Our Case Number: ABP-317767-23

Re: Proposed construction of 39 residential units, widening of Pausdeen Bridge and all associated site works.
Newtown/Ardclough Road, Newtown, Celbridge, Co. Kildare.

Please find below enclosed my observations on the proposed development at Newtown Road / Ardclough Road, Newtown, Celbridge Co. Kildare, for the "Proposed Construction of 39 residential units, widening of Pausdeen Bridge, and all associated site works".

Fig 1

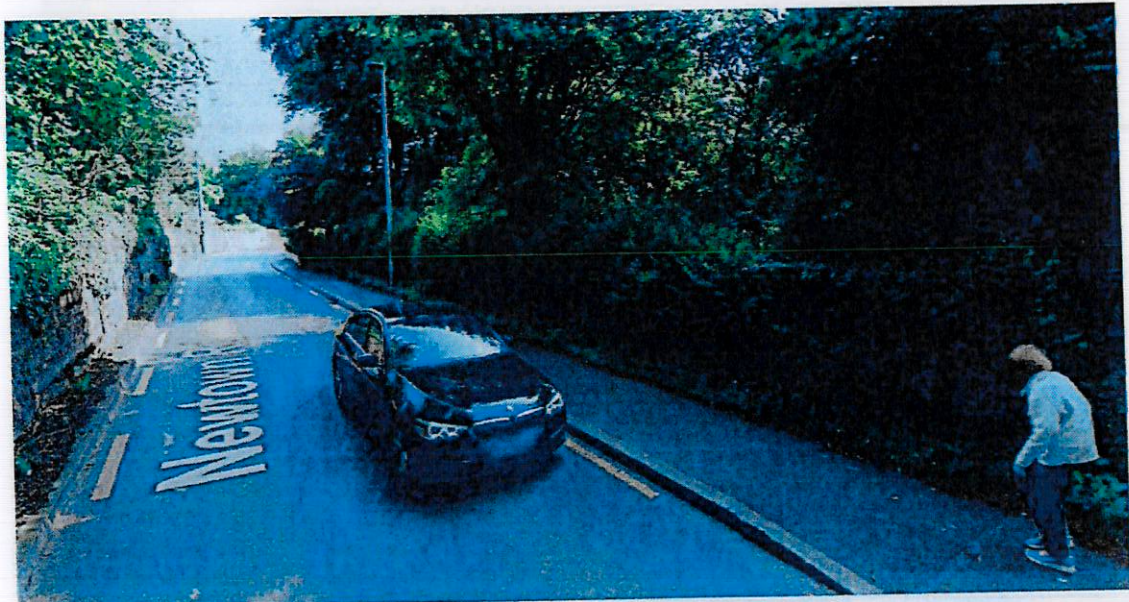
the village of Celbridge, and or the Irish Rail station at Hazelhatch. To travel by foot to either destination, there are significant deficiencies in footpath widths at two locations; Dwelling at 'Abbyside' (Fig. 1) , approximately 900m north of the subject site along the Ardclough Road, and from 'The Grove' housing estate past the 'Abbey National School 1891' (Fig. 4) to the pedestrian crossing at the Liffey bridge at 'Hawthorn Cottage', a stretch of 290 metres. Pedestrians frequently step out on to the road in both locations to pass other pedestrians, push-chairs or cycles. The footpath from the subject site to Celbridge is very frequently used by children cycling unaccompanied to school.

- a. At Abbyside house (53.33305,-6.54486), the footpath is less than 1m in width, unprotected, on a sharp bend at a narrowing of the road. Vehicles frequently mount the kerb at speed here to avoid collision with oncoming vehicles.
- b. From the Grove to the Liffey bridge pedestrian crossing, there is 290 metres of narrow unprotected footpath, in places less than 1m in width. The road frequently floods here also.
- c. Further development on the Ardclough road in Celbridge without providing for;
 - i. Traffic calming;
 - ii. Cycle segregation;
 - iii. Safe width pedestrian footpaths;the absence of which will result in significantly increased risk of injury or fatality along the Ardclough road.
